TOWN OF OLD SAYBROOK  
Conservation Commission

XC:PC 11/17  
PLANNING  
COMMISSION  
EXHIBIT #61

Subject: "The Preserve" Preliminary Open Space Subdivision & Open Space Plan  
Ingham Hill and Bokum Roads (Maps 55, 56 & 61, Lots 6, 3, 15, 17 & 18)  
Residence Conservation C District, Aquifer Protection Area  
Applicant: River Sound Development LLC, Agent: Robert A. Landino, P.E.

(Elimination of a portion of Road A)

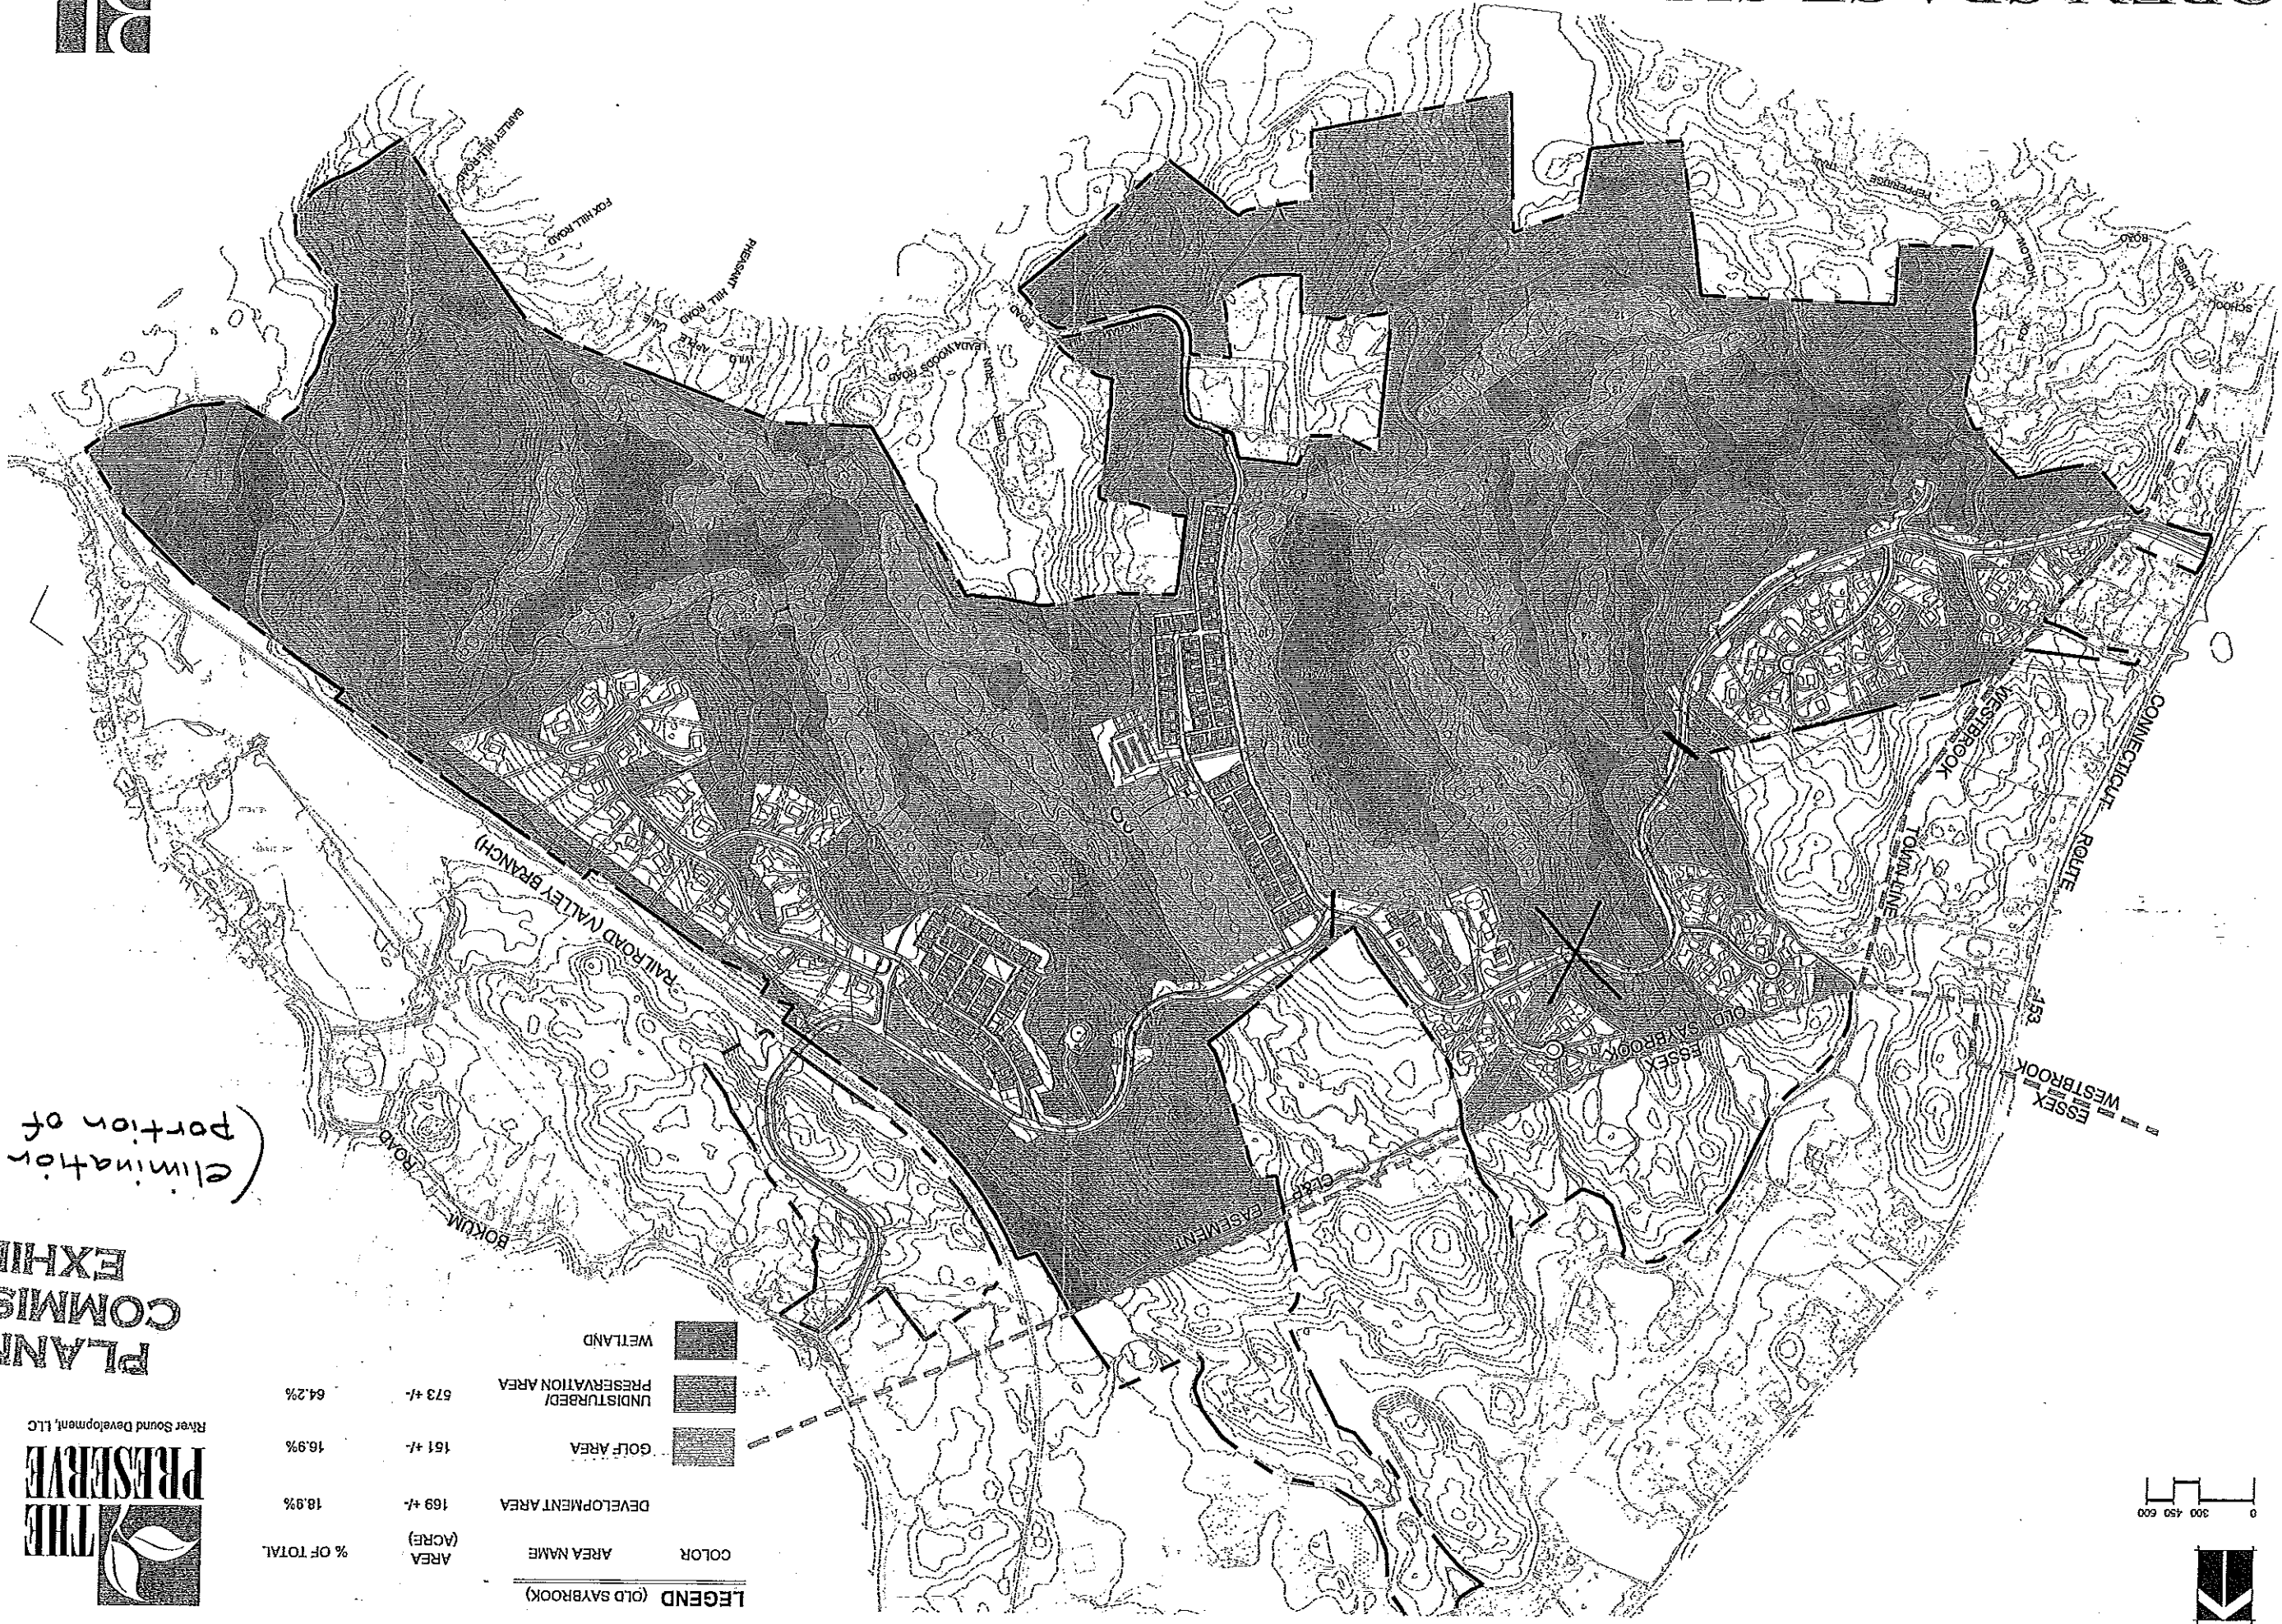
The natural structure of the land runs north-south, while the main infrastructure of the development proposal runs primarily east-west. This results in a requirement for extensive cuts and fills that cause large disturbances of vegetation, wildlife habitats, soil and rock, which in turn result in a serious risk for erosion, sedimentation and airborne particulate pollution. It would be helpful to see a plan showing the areas that will have to be disturbed in this way for the construction of the proposed development.

The <sup>west</sup> east side of the proposed development contains a large portion of the most sensitive wetlands on the property, including a significant part of the headwater streams of the Oyster River. The elimination of the large infrastructure in this area would provide a great environmental plus. This could be accomplished by eliminating the portion of Road A between Road C and Road H, and then connecting Road H through the Village area to Ingham Hill Road. In addition, if the piece of Road A just west of the proposed fire house were routed around the wetland on the north side, these road changes would eliminate all wetland crossings and the accompanying bridge structures.
